L190-E980572-00-D

ENGINEERING CHANGE REQUEST (ECR)

DRAWING TITLE HAM Isolation Stack Leg Assembly

REVISION: FROM C TO D

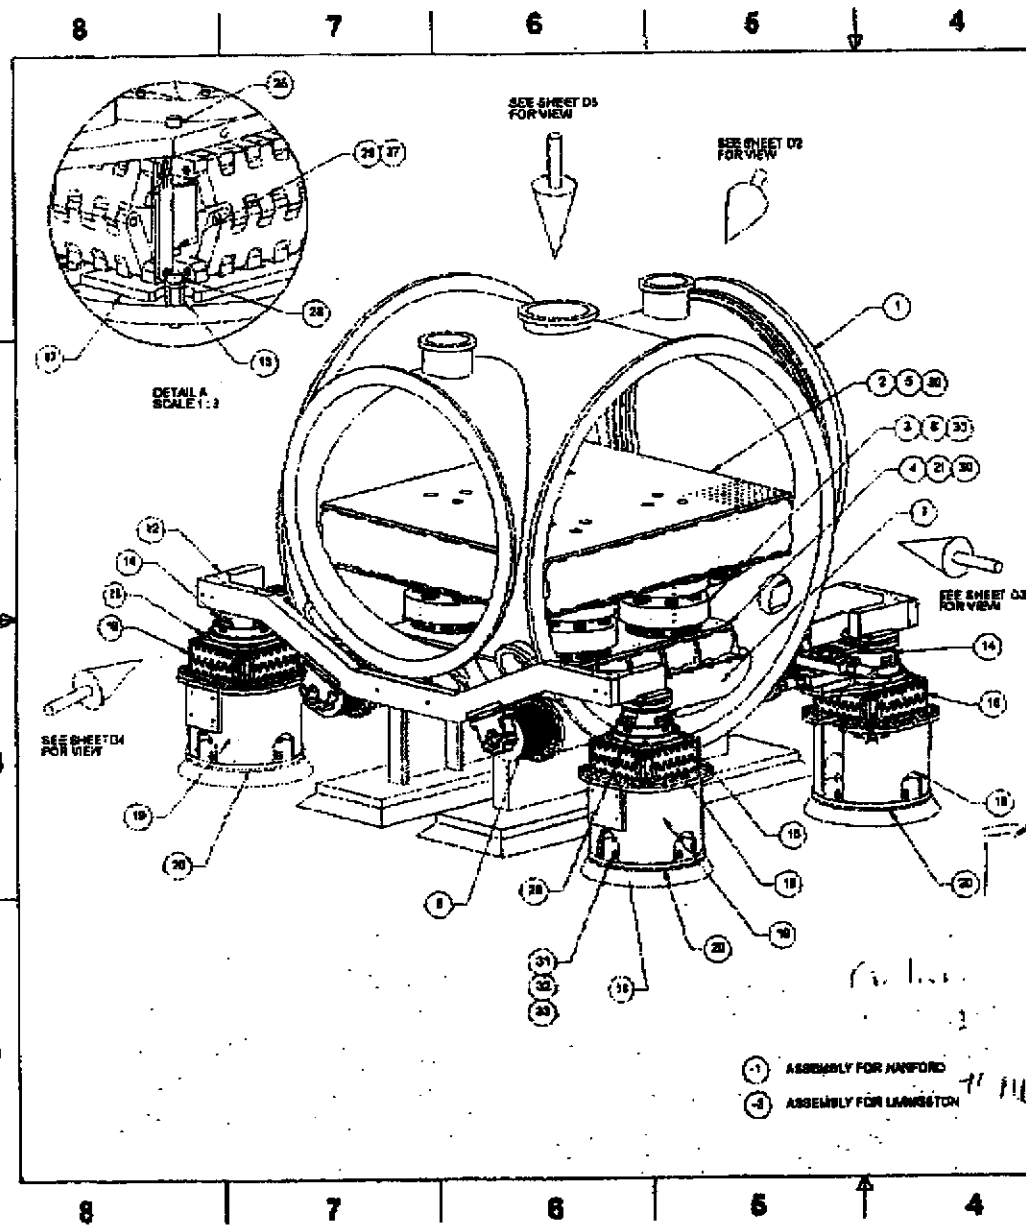
Add D97216 (Custom vented washer, see attached)
to item #3 on 972701 & Item #9 on 972501

Safety lenses are not long enough
